Building Code of Australia 2022 Report

Report for BCA Compliance

PROJECT NAME: Vincentia High School Upgrade - 142 The Wool Road, Vincentia NSW 2540

DATE: 31/03/2025 (REF) – Rev F

BCA Assessment – Markup Plans

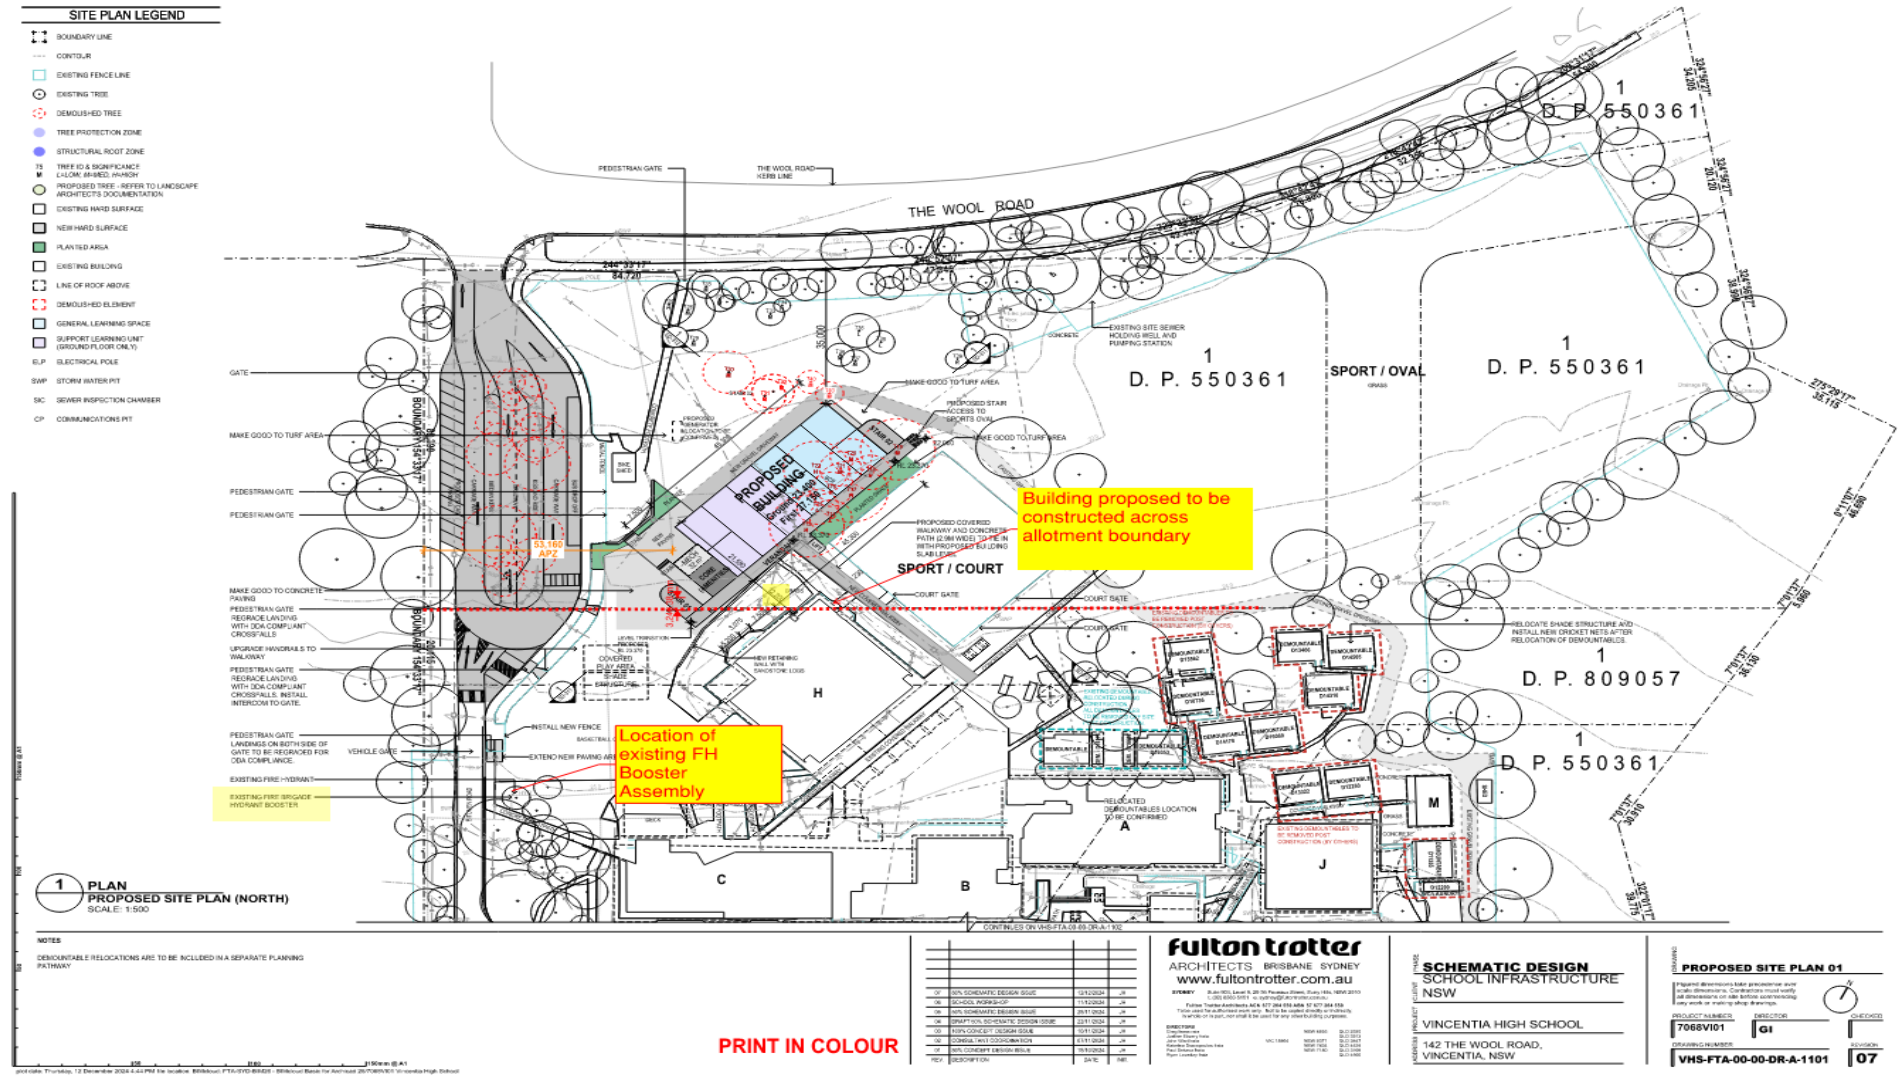
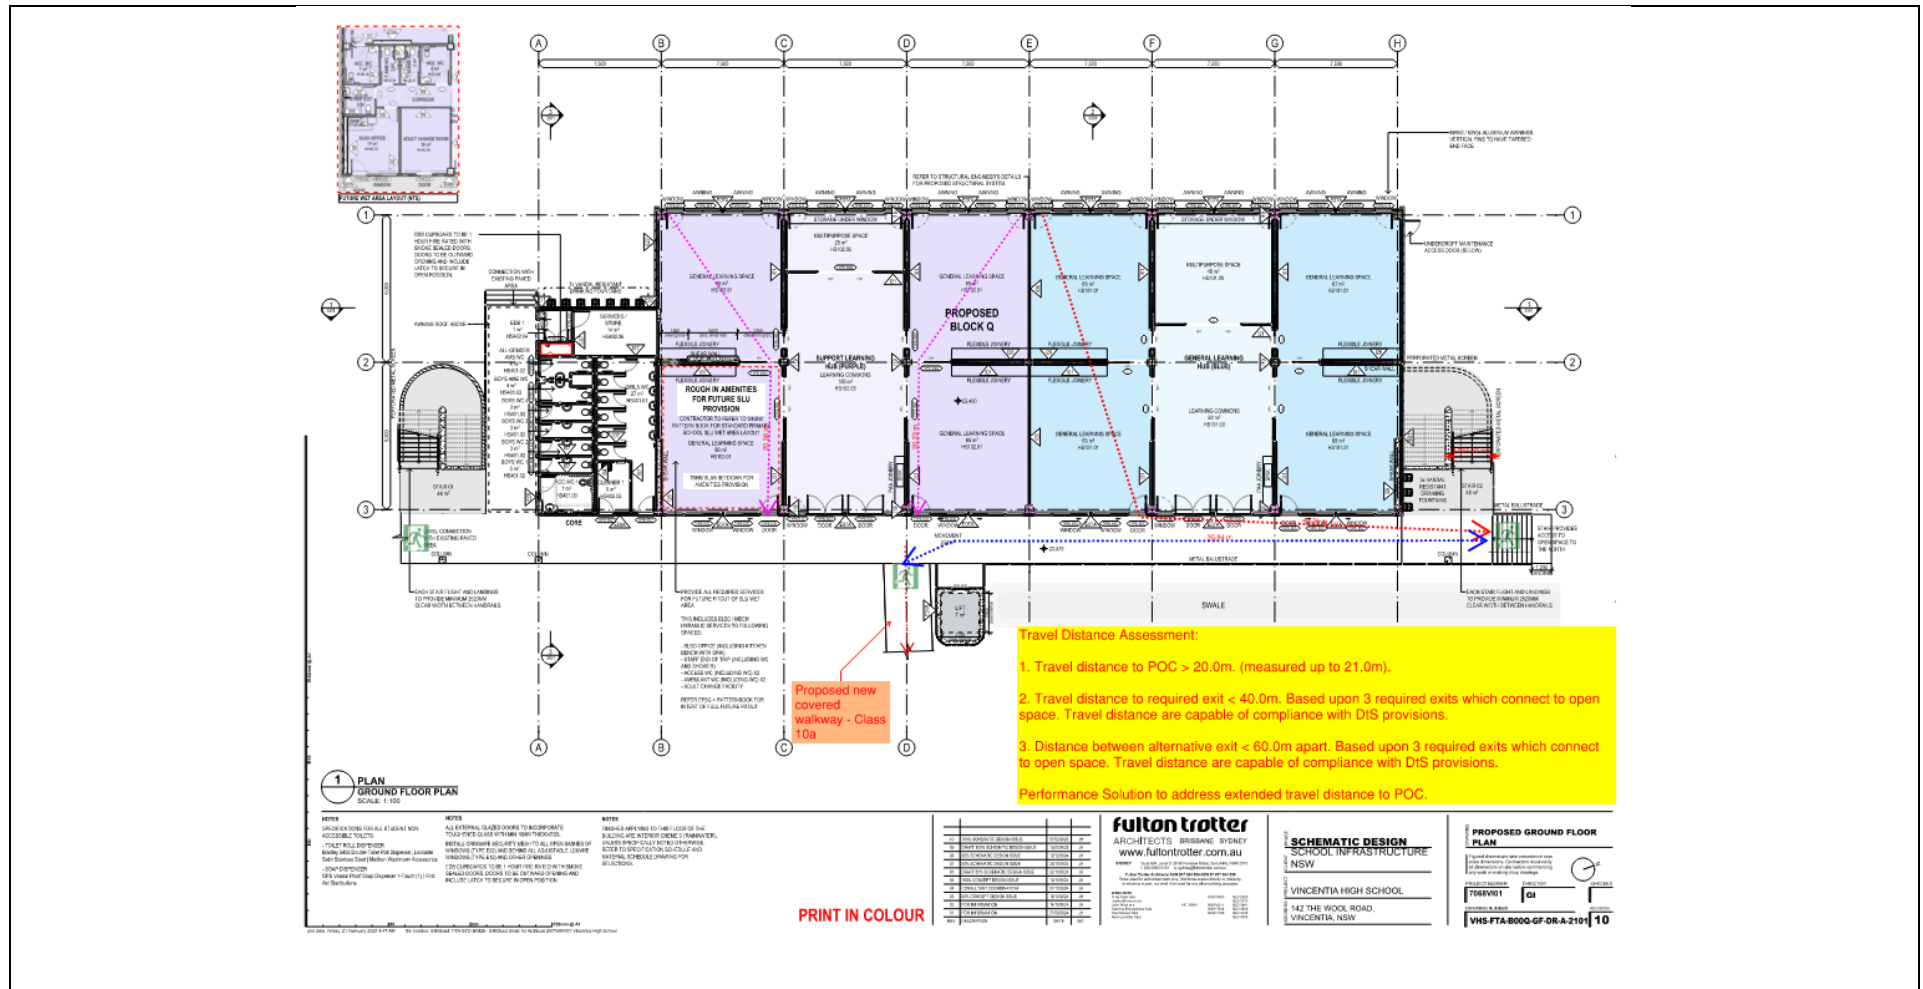
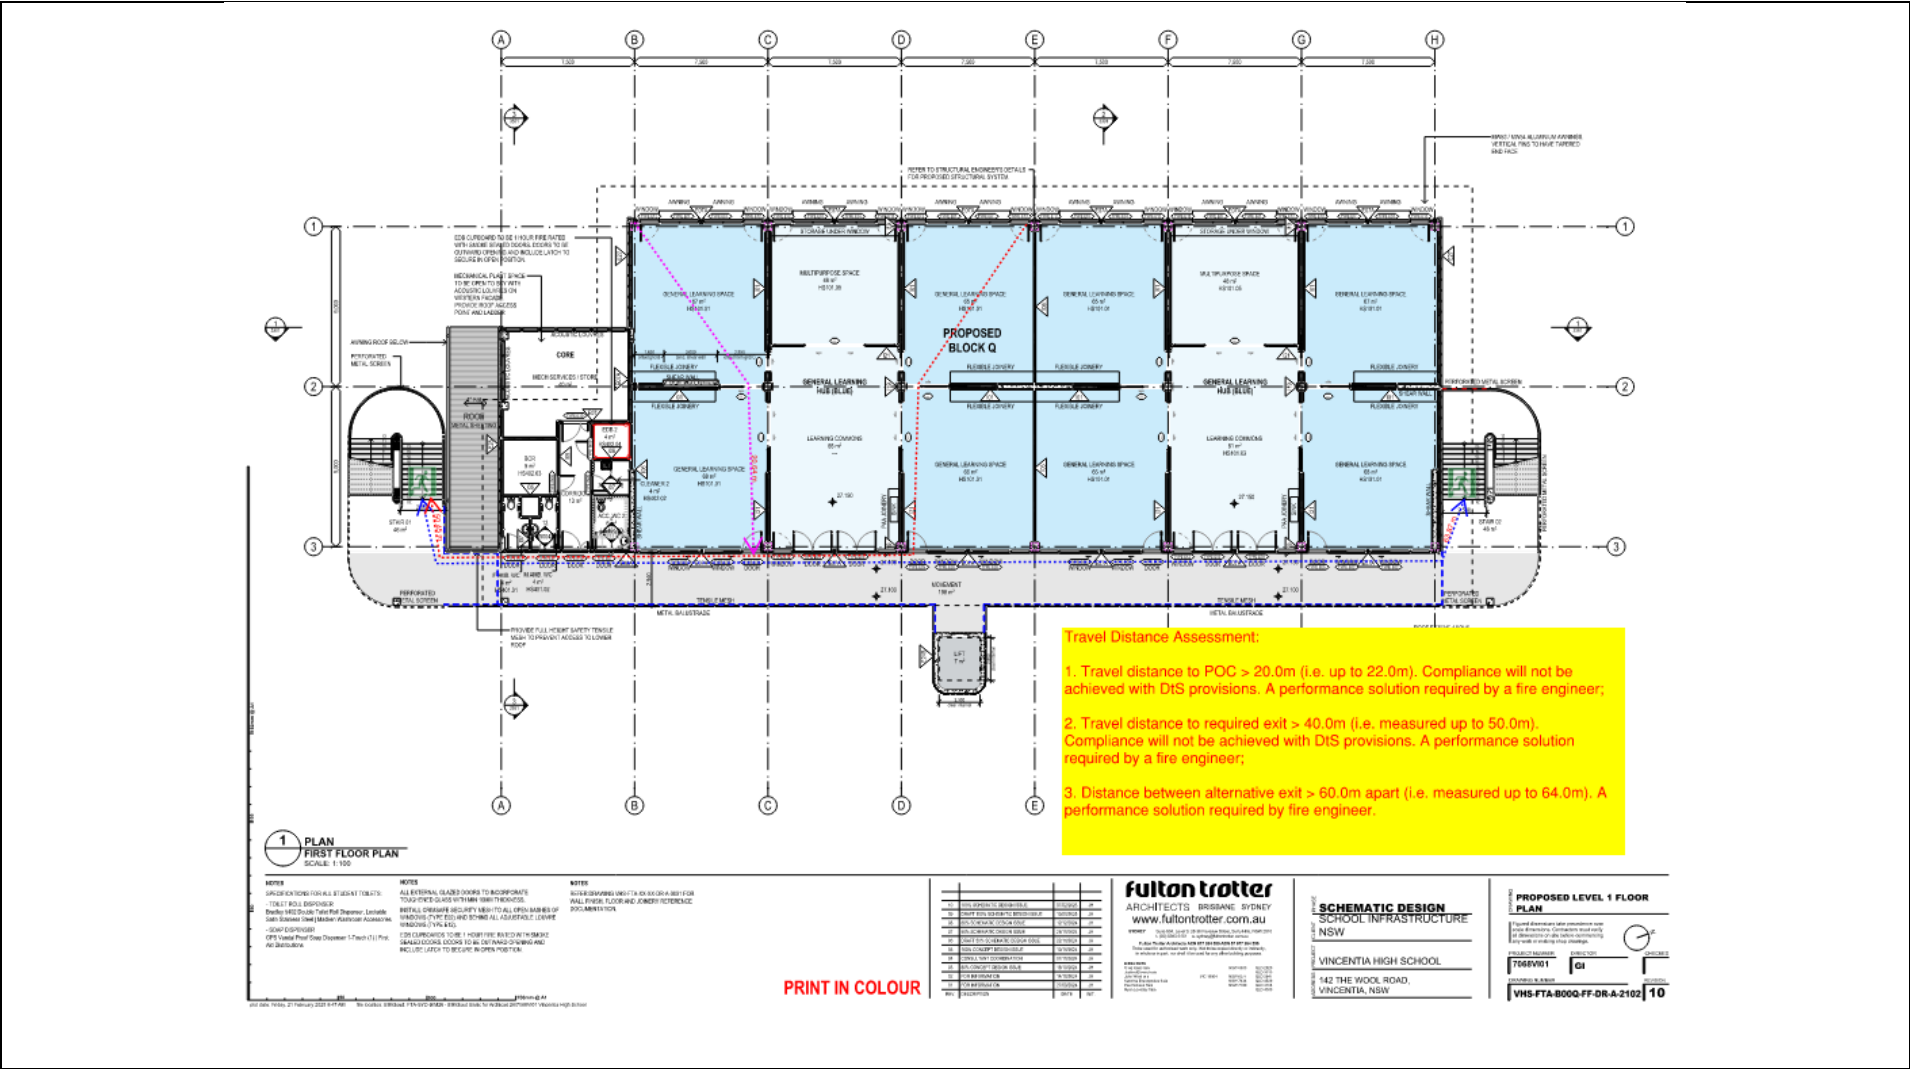
Initial review of the architectural drawings indicates that travel distances will not comply with the DtS provisions of the BCA. Refer to Appendix A. This will require a performance solution from a fire engineer to comply with the performance requirements of BCA 2022.

2.	<u>Travel Distance exceed the DtS provisions:</u> ➤ Travel distance to point of choice to alternative exits > 20.0m (i.e. measured up to 22.0m within Ground and Level 01); ➤ Travel distance to required exit > 40.0m (i.e. measured up to 50.0m) within Level 01. ➤ Distance between alternative exit > 60.0m apart (i.e. measured up to 64.0m) within Level 01.	D2D5 & D2D6	D1P4, E2P2
